NOTE
 THIS DRG. IS ONLY FOR THE PURPOSE OF CONSTRUCTION OF ROOM / TOILET/ STORE ALLOWED UNDER NEEDBASE CHANGES 23-3-2010
 THE PROPOSAL OF ADDITIONAL CONSTRUCTION UNDER CLAUSE A3 NEEDBASE CHANGES 23-3-2010 IS MARKED ON THE DRG. BASED ON APPROVED DRG. NO. 16 JOB NO. 82 ALONG WITH R.W.P. DISPOSAL.
 FOR ANY OTHER DETAIL / NOTES REF. DRG. NO. 16 JOB NO. 82

Chief Architect.	Senior Architect.
Civil Engineer.	Superintending Engineer CHB.	Architect CHB.
Structure Engineer.	SCALE:	DATE :-
Elect. Engineer.	(Shashi Thakur) PLANNING ASST. DRAWN BY	82 JOB NO. 23 DRG. NO.
Fire Fighting.	STANDARD DESIGN OF NEED BASED CHANGES FOR SELF FINANCING - SCHEME FOR - THREE ROOM FLATS SECTOR 42 - C CHANDIGARH GROUND FLOOR PLAN	
Ph. Engineer.

FIRST FLOOR PLAN

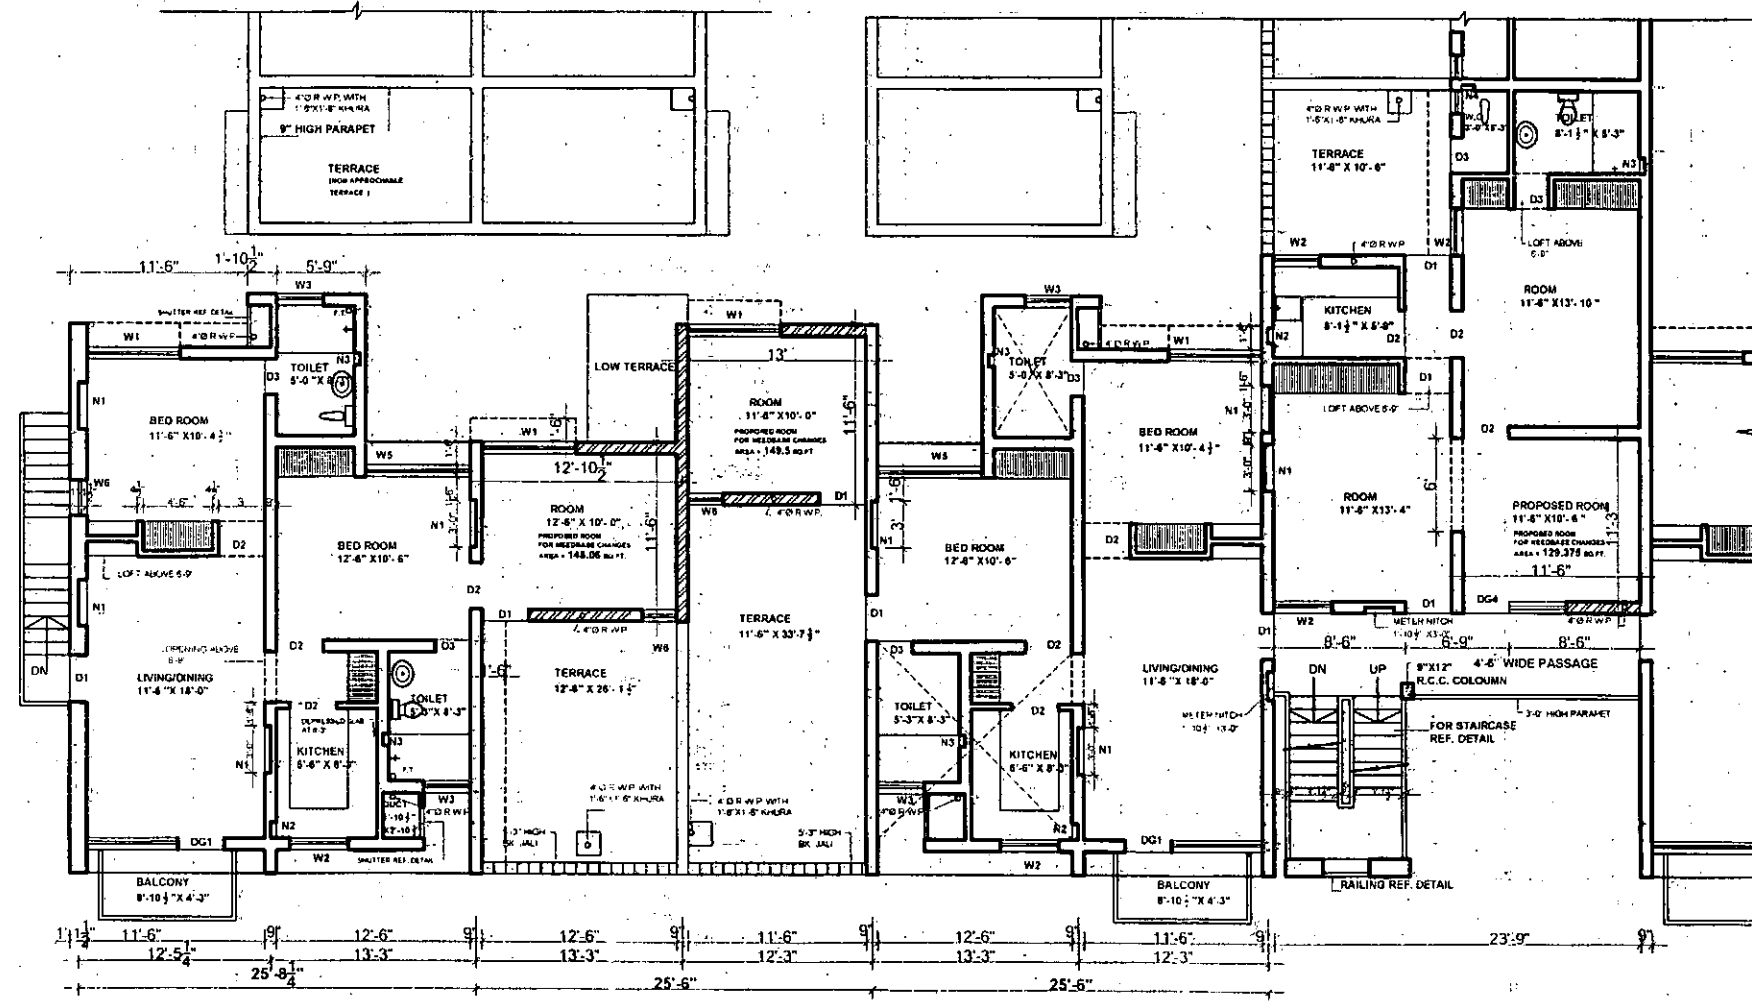
THIS DRG. IS ONLY FOR THE PURPOSE OF CONSTRUCTION OF ROOM / TOILET/ STORE ALLOWED UNDER NEEDBASE CHANGES 23-3-2010

THE PROPOSAL OF ADDITIONAL CONSTRUCTION UNDER CLAUSE A3 NEEDBASE CHANGES 23-3-2010 IS MARKED ON THE DRG. BASED ON APPROVED DRG. NO. 17 JOB NO. 82 ALONG WITH R.W.P. DISPOSAL.

SECOND FLOOR PLAN

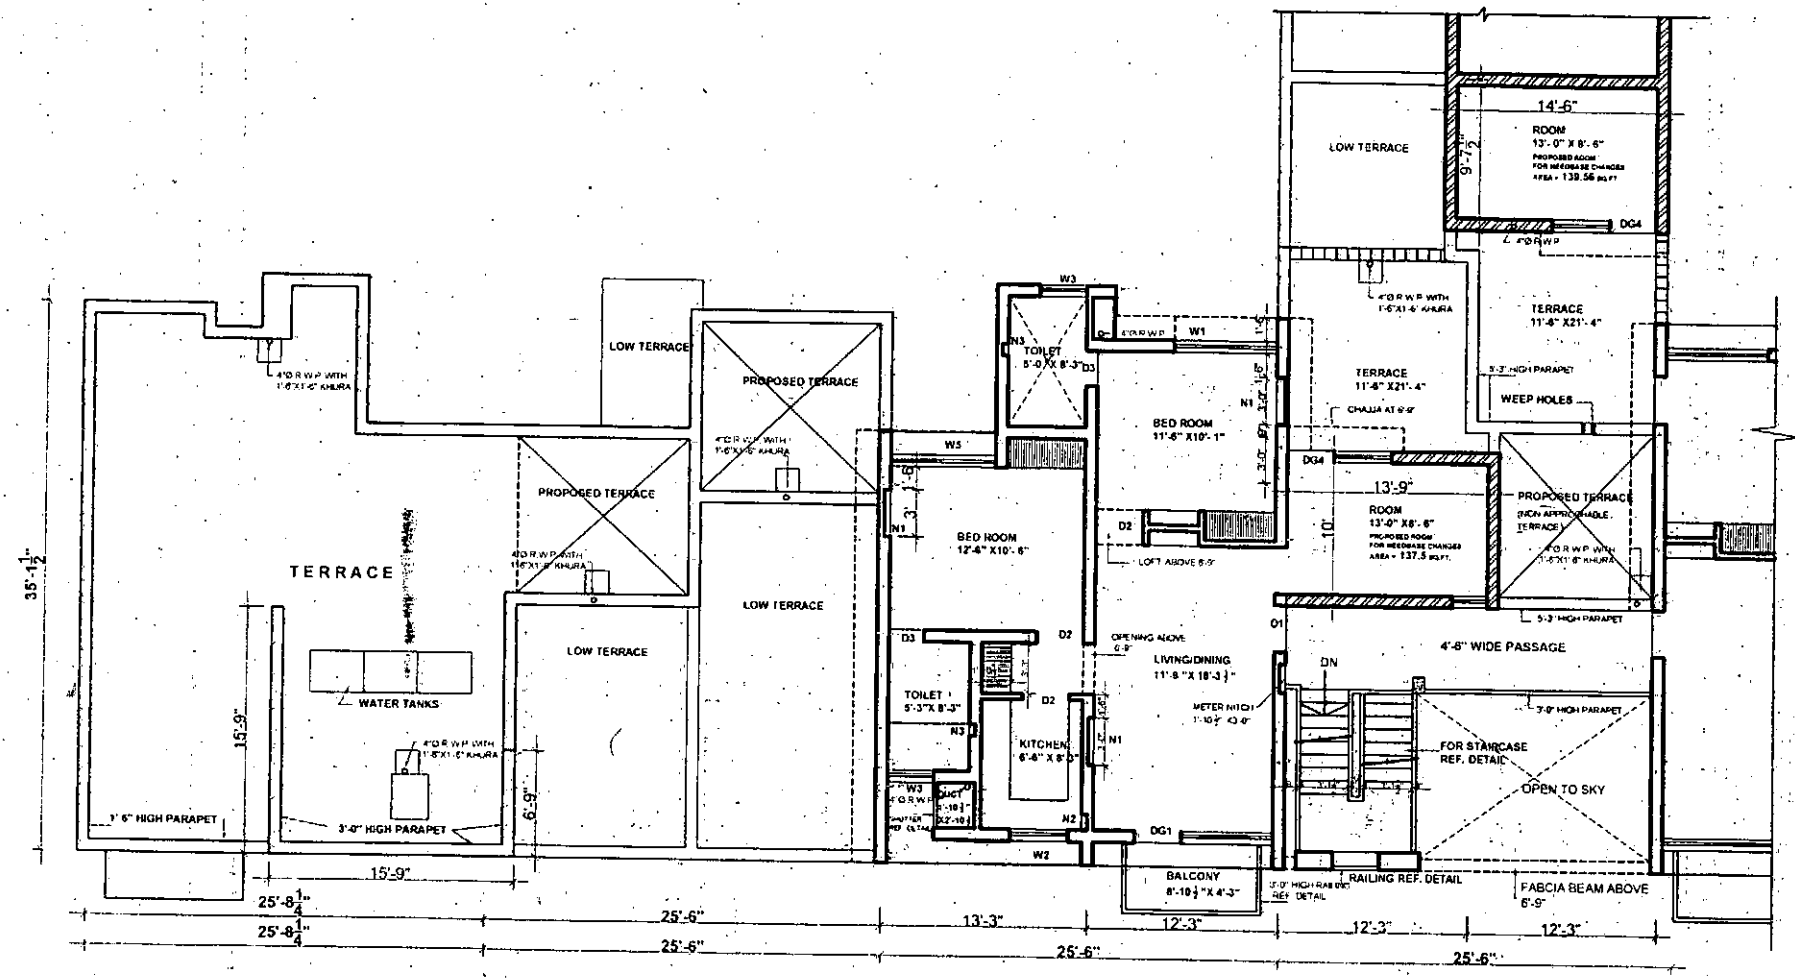
THIS DRG. IS ONLY FOR THE PURPOSE OF CONSTRUCTION OF ROOM / TOILET/ STORE ALLOWED UNDER NEEDBASE CHANGES 23-3-2010

THE PROPOSAL OF ADDITIONAL CONSTRUCTION UNDER CLAUSE A3 NEEDBASE CHANGES 23-3-2010 IS MARKED ON THE DRG. BASED ON APPROVED DRG. NO. 18JOB NO. 82. ALONG WITH R.W.P. DISPOSAL.

TERRACE FLOOR PLAN

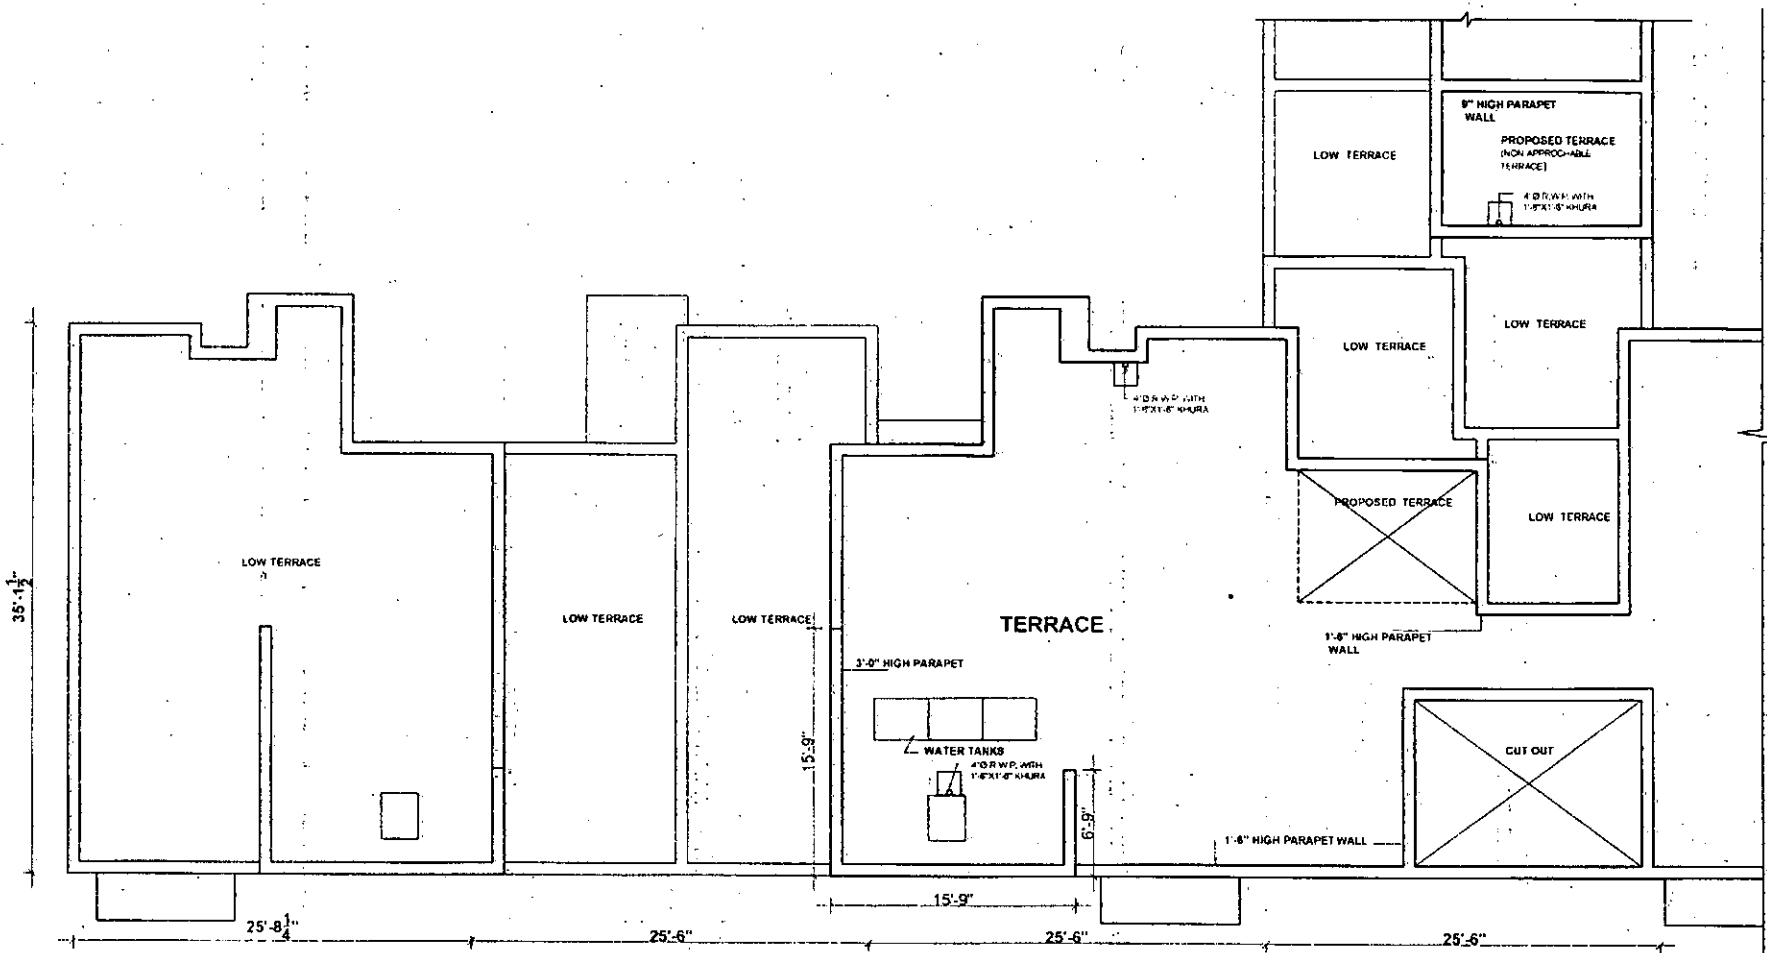
THIS DRG. IS ONLY FOR THE PURPOSE OF CONSTRUCTION OF ROOM / TOILET/ STORE ALLOWED UNDER NEEDBASE CHANGES 23-3-2010

THE PROPOSAL OF ADDITIONAL CONSTRUCTION UNDER CLAUSE A3.NEEDBASE CHANGES 23-3-2010 IS MARKED ON THE DRG. BASED ON APPROVED DRG. NO. 19 JOB NO. 82 ALONG WITH R.W.P. DISPOSAL.
